STAFF RECOMMENDATION

SMITHSONIAN INSTITUTION
PERIMETER SECURITY AT THE NATIONAL MUSEUM OF NATURAL HISTORY
The National Mall, Madison Avenue and 12th Street, NW

Submitted by the Smithsonian Institution

May 29, 2008

2008 site plan showing security perimeter

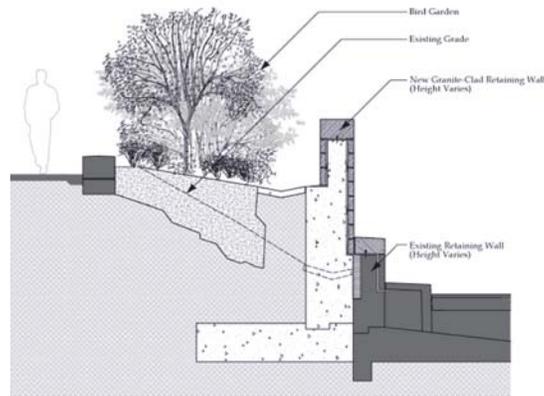
2008 elevation, plan, and section showing cable posts and stays with new plantings.

2008 planting plan, primarily with Chinese juniper and Mountain Laurel, but with an extensive variety of plants designed to attract birds. The more mature trees and shrubbery at the rear of the planting beds was to have been removed in the earlier plan but can be retained in the current proposal. The new plantings will grow up and over the posts and cables.

2006 site plan showing security perimeter

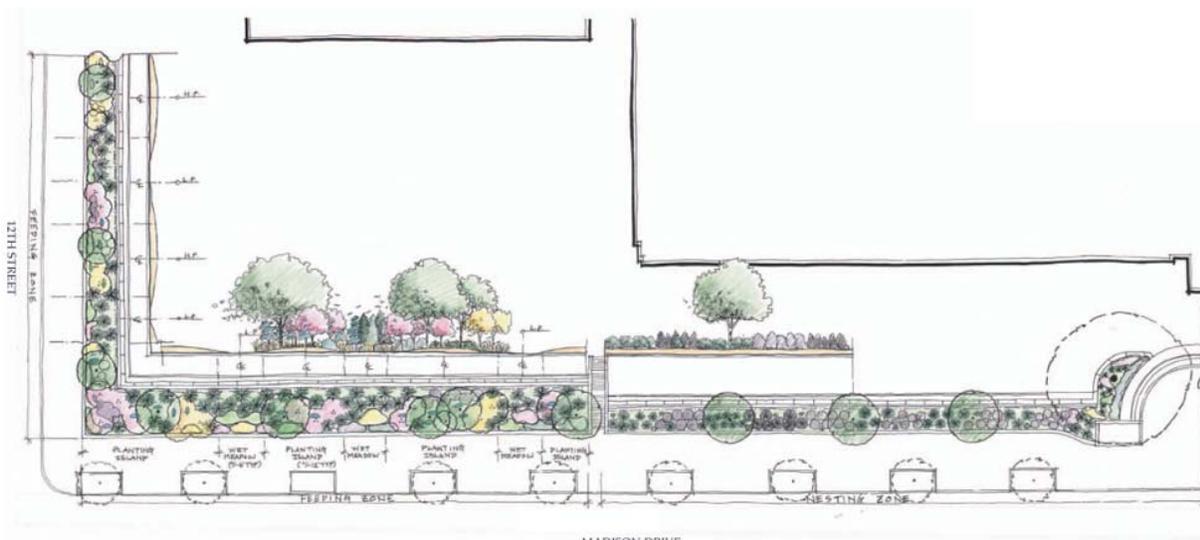
2006 section of retaining wall at rear of planting bed between sidewalk and the sunken parking lot.

2006 planting plan showing retaining wall at rear of beds. The Bird Garden will also be planted in the current proposal.
